Planning Commission Staff Report

Project Type: Amended Architectural Elevations

Description: **Spirit Trade Center, Lot 12A (Club Dog):** Amended Architectural Elevations and Amended Architect’s Statement of Design for a 2.01 acre “LI” Light Industrial District – zoned property located a half mile southwest of the intersection of Chesterfield Airport Road and Trade Center Boulevard.

1 SOUTH ELEVATION
 Scale: NTS

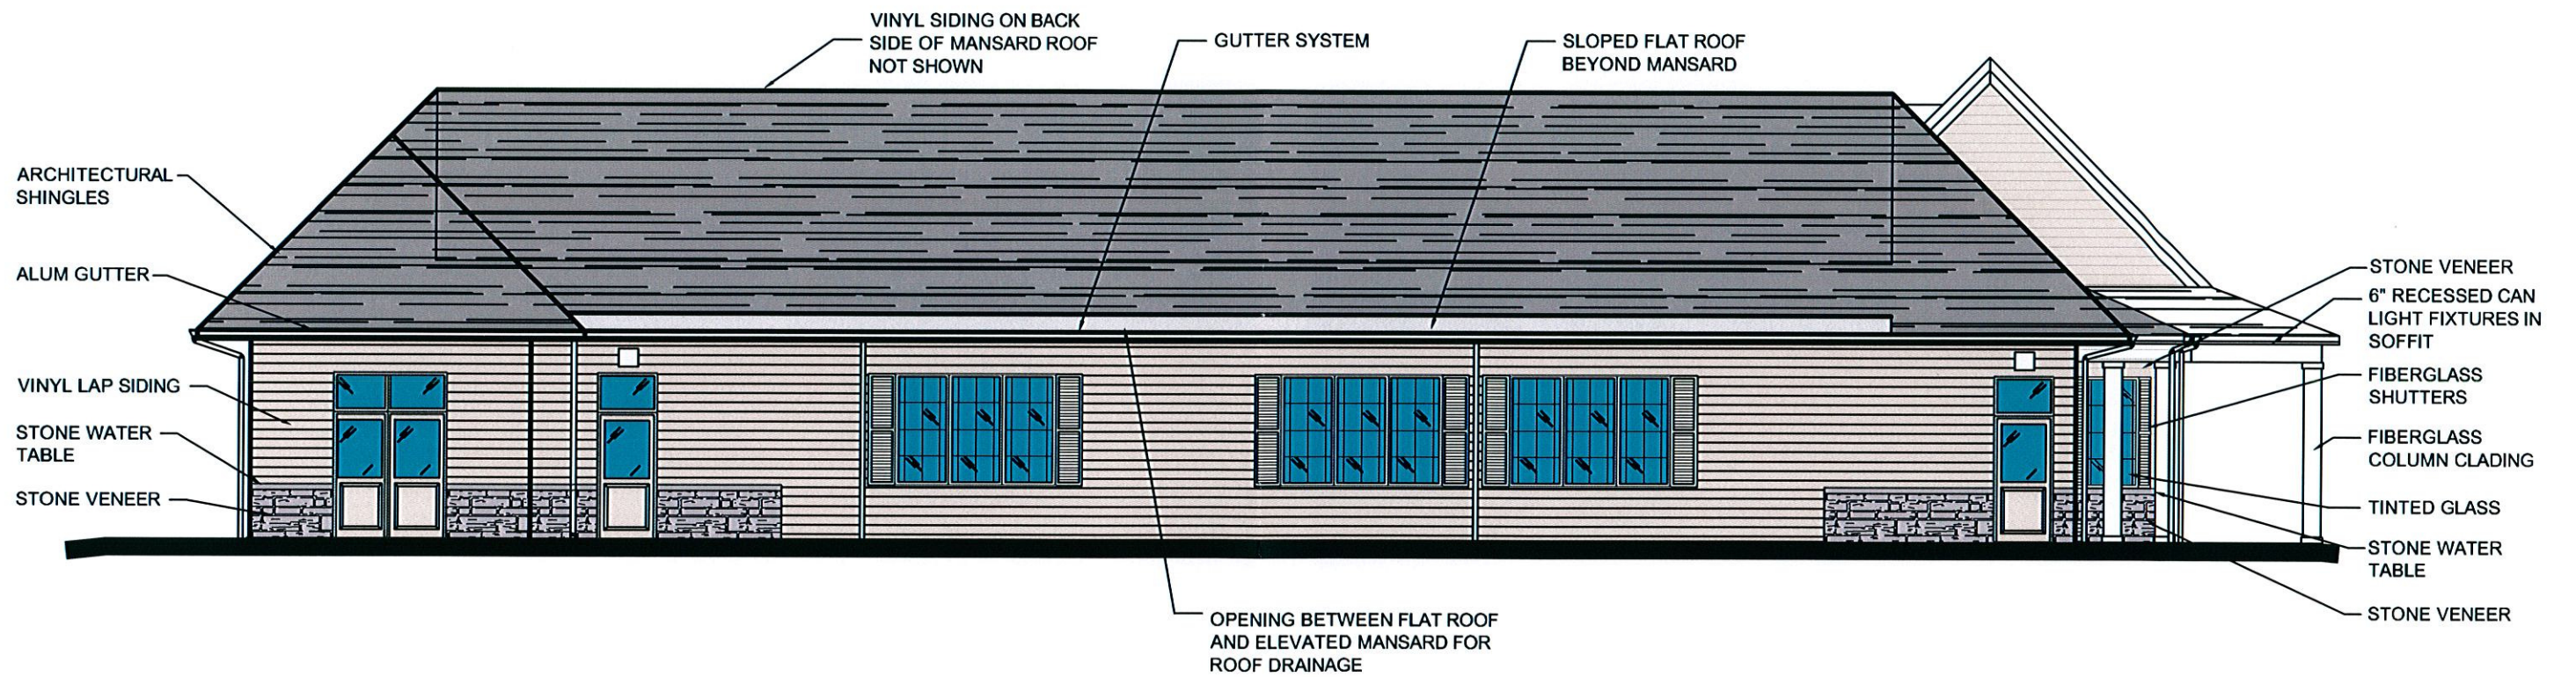
1. Eliminate the stone from the upper portion of the walls along the front elevation.
 - The applicant has elected to remove the stone from the upper portion of the front (south) elevation reducing it down to the wainscot height.

3. Revise the roof on the west elevation to mimic the appearance of the original roof design and incorporate visual screening of the planned rooftop mechanical equipment.

- The applicant has added the mansard roof back on the western elevation to give the appearance of the original roof design and to screen rooftop mechanical equipment. The west mansard roof will have a one (1) inch gap for sheet drain purposes.

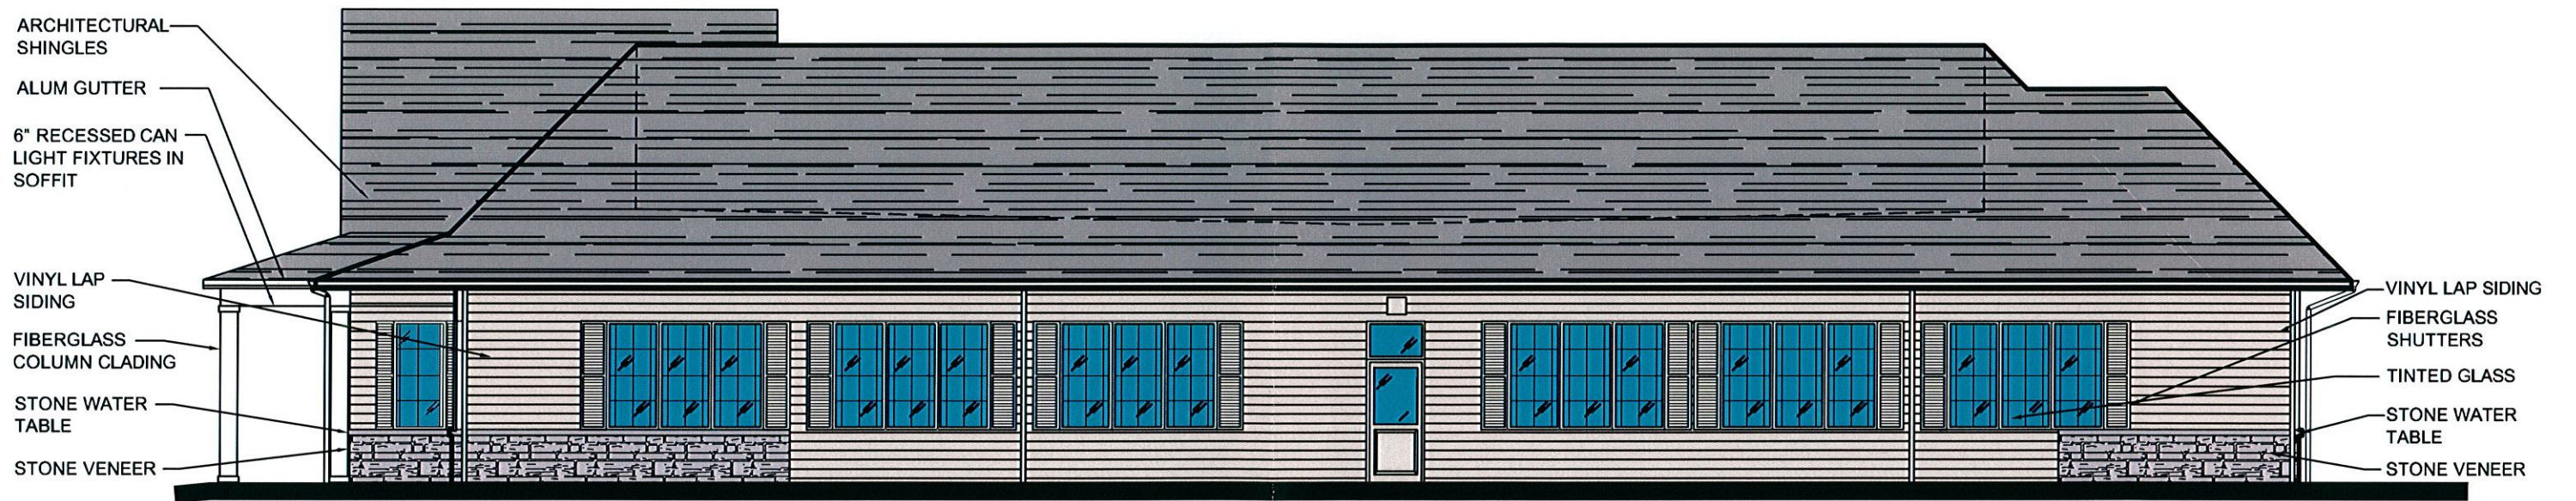
2. Stone should be added at wainscot height on all four sides of the building but at least on both corners of the north, south and west elevations.
 - The applicant has added stone to all four sides of the building using the material to wrap each of the corners at wainscot height.
